Clause 104 Cleanup

SANTA BARBARA DESIGN CENTER

Presentation Outline

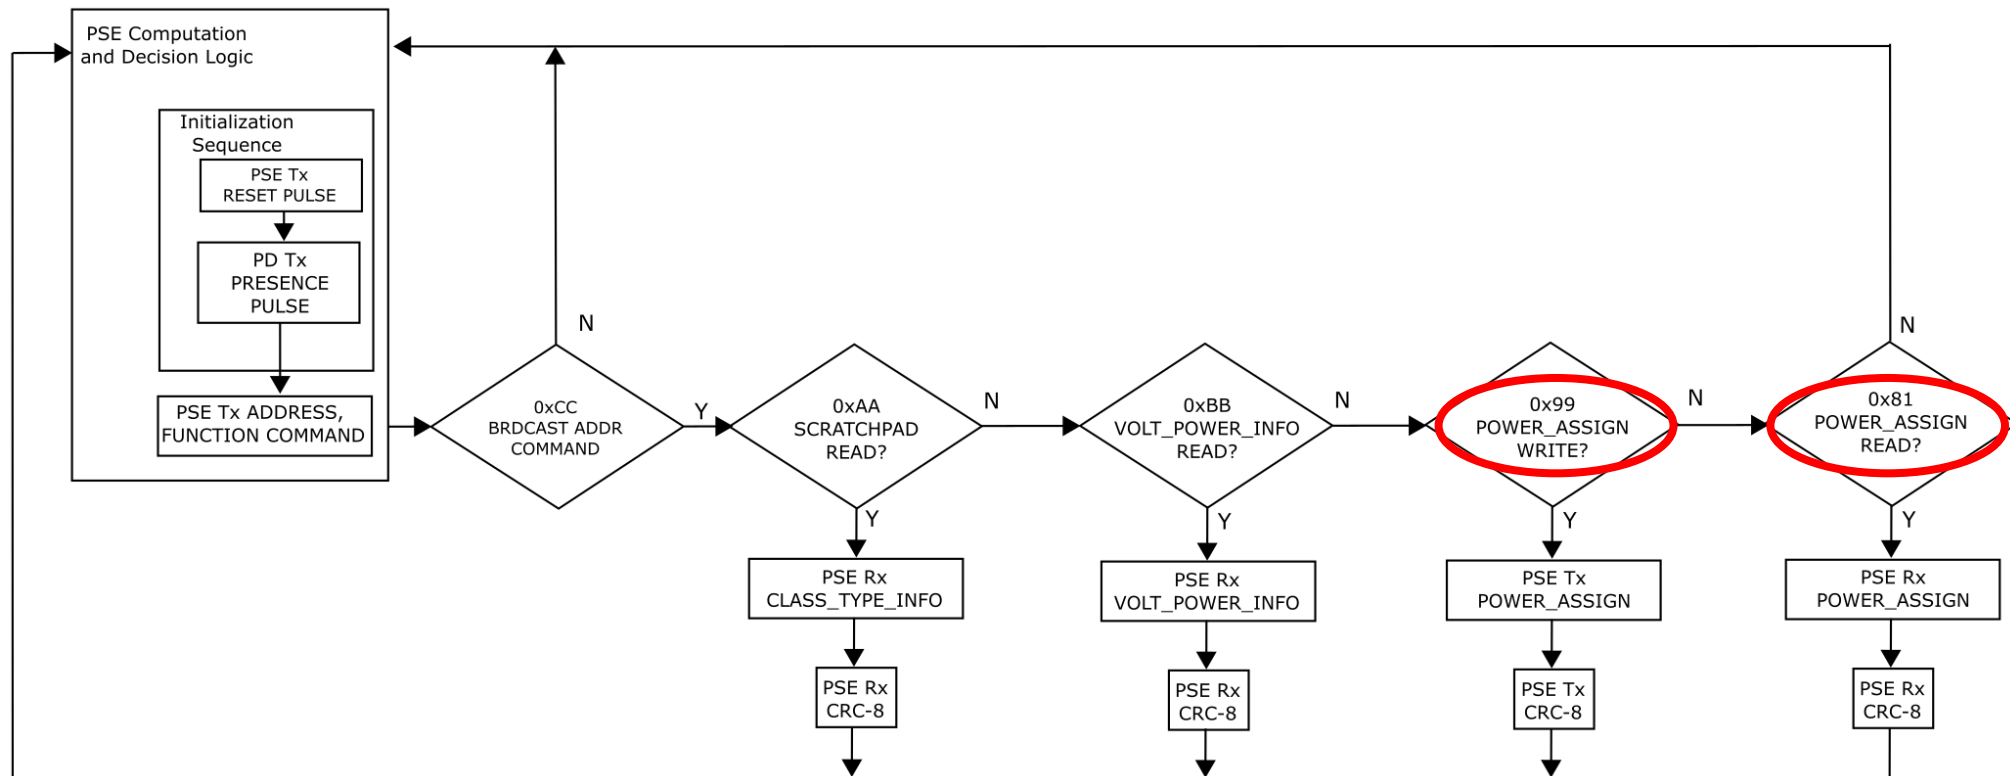
Rename in SCCP Flowchart

- Flowchart with modified command names
- Replace Figure 104-13 with the one shown below (name changes):

Figure 104-14—CRC8 field generation

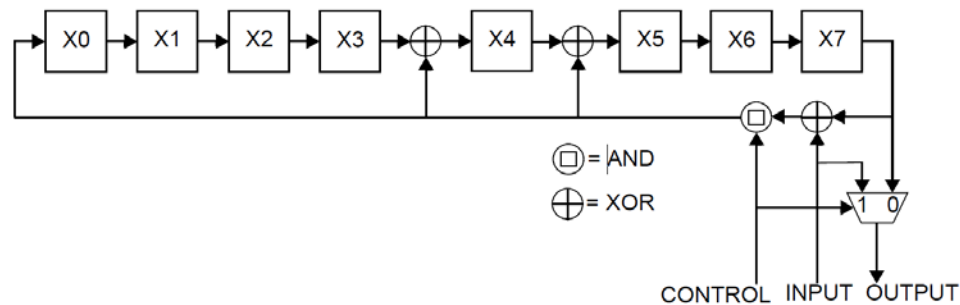
- CRC calculation to include all SCCP commands
- Modify 104.7.2.5 and Figure 104-14 as shown below:

The CRC8 field is an 8-bit cyclic redundancy check value. This value is computed as a function of the contents of the preceding 16-bit ~~Scratchpad Read~~ Read/Write payload.

CONTROL = 1 when shifting the contents of the ~~CLASS_TYPE_INFO~~ register and calculating the CRC field
CONTROL = 0 when transmitting the CRC field
